COUNTY OF ST. CLAIR

**Subject: Smiths Creek Landfill (SCL)
Response to January 16, 2024 Violation Notice**

CONCEPTUAL SITE MITIGATION PLAN

Attachment 1: Closed Area Re-Grading Locations

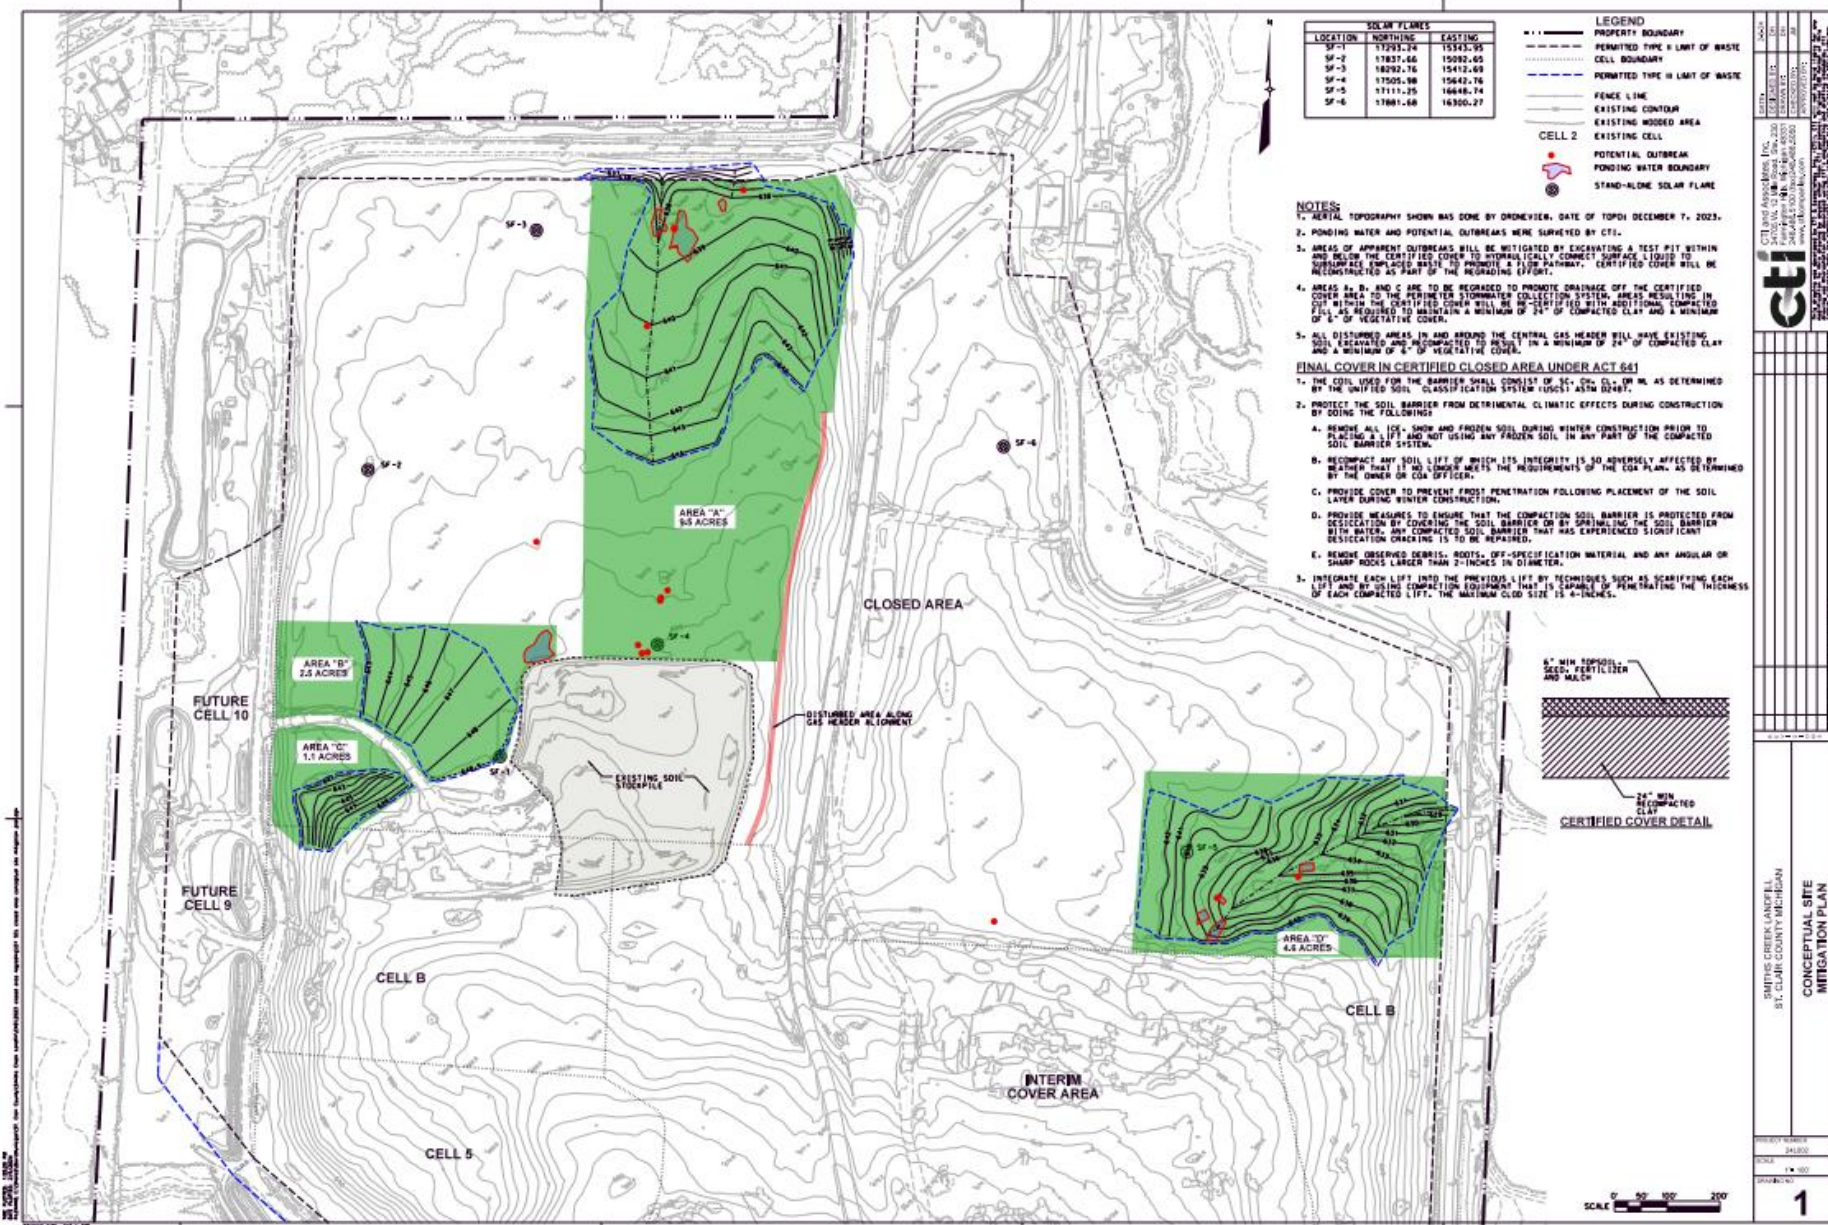
"Ponding liquid was observed at multiple locations throughout the certified closed area of the Facility. These topographic low areas throughout the certified closed area require attention to prevent erosion and water infiltration. An annual flyover was scheduled for August 2023 to create a topographic survey of the certified closed area final cap surface to prepare localized grading adjustments to improve water flow from the final cap. The data from the survey was scheduled to be prepared in August 2023, with localized re-grading

occurring in September/October 2023. Documentation of the completion of re-grading activities must be submitted to MMD for review.”

“Several areas without vegetation were observed throughout the certified closed area of the Facility. Re-vegetation was scheduled to occur in October 2023 after topographic low areas of the final cap were re-graded. These areas require seeding to establish vegetation that will minimize erosion of the final cover and water infiltration into the fill. Documentation of the completion of seeding activities must be submitted to MMD for review.”

“Severe erosion of the final cover was observed in multiple areas of the certified closed area of the facility. Inspection of these eroded areas resulted in exposed waste being observed. Re-grading of the gas collection and control system header also disturbed the final cap of the certified closed area. These areas of the clay cap need to be repaired, and certification documentation that the final cover meets the requirements of Part 115 needs to be provided.”

The closed area cap repair efforts are scheduled to resume in second quarter 2024 as weather permits. Attachment 1 details the plan which includes three primary areas of regrading designed to improve drainage in areas where significant settlement has occurred over time. Documentation of the repairs and re-certification, where applicable, will be conducted in accordance with the approved closure. Documentation of repair activities will be provided to EGLE within 30 days of completion of the repair activities (no later than July 31, 2024).

Response: As noted above, the re-grading work previously scheduled for completion during 4th quarter of 2023 was postponed due to implementation of higher priority tasks to directly address off-site odor issues. Re-grading and subsequent re-vegetation is scheduled to be completed during the 2nd quarter of 2024 in conjunction with the regrading effort. At that time, seeding will be conducted in areas disturbed during the regrading effort. Other cap surfaces outside of the re-grading areas with little or no vegetation will similarly be re-seeded at that time. Seeding will be conducted using grass varieties suited to the local climate and soil conditions as recommended by the United States Department of Agriculture Natural Resources Conservation Service Critical Area Planting standard (Code 342, 2016) and stabilized with an appropriate mulch material. Documentation of this work will be submitted to EGLE no later than July 31, 2024.

Response: Erosion noted in the certified closed area during the time of EGLE’s inspection was determined to be the result of stormwater damage in areas of settlement. Three areas of significant erosion have been identified as the primary focus of the re-grading plan described above and in Attachment 1. Correction of settlement will simultaneously resolve current erosion and limit future erosion potential. The corrective measures are scheduled to be completed by the end of second quarter, 2024 as weather conditions permit. Documentation will be provided by July 31, 2024 as described previously.

- AREAS A, B, AND C ARE TO BE REGRADED TO PROMOTE DRAINAGE OFF THE CERTIFIED COVER AREA TO THE PERIMETER STORMWATER COLLECTION SYSTEM. AREAS RESULTING IN COVER WITHIN THE CERTIFIED COVER SHALL BE RE-CERTIFIED WITH ADDITIONAL COMPACTED FILL AS REQUIRED TO MAINTAIN A MINIMUM OF 24" OF COMPACTED CLAY AND A MINIMUM OF 1" OF VEGETATIVE COVER.

- ALL DISTURBED AREAS IN AND AROUND THE CENTRAL GAS HEADER WILL HAVE EXISTING SOIL EXCAVATED AND RECOMPACTED TO RESULT IN A MINIMUM OF 24" OF COMPACTED CLAY AND A MINIMUM OF 1" OF VEGETATIVE COVER.
